JENSAMP-51X

rev02 PCB overlay

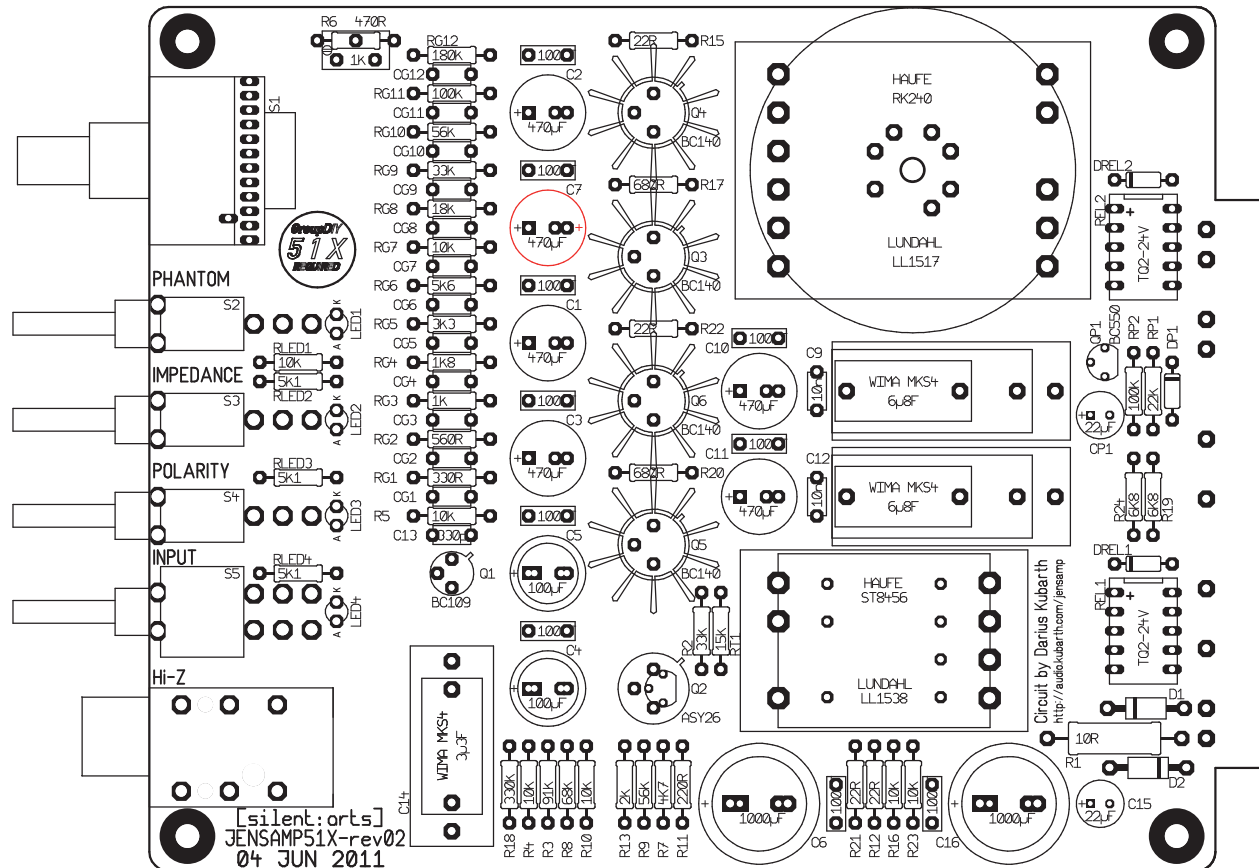
note: change polarity of C7 to reduce gain change clicks
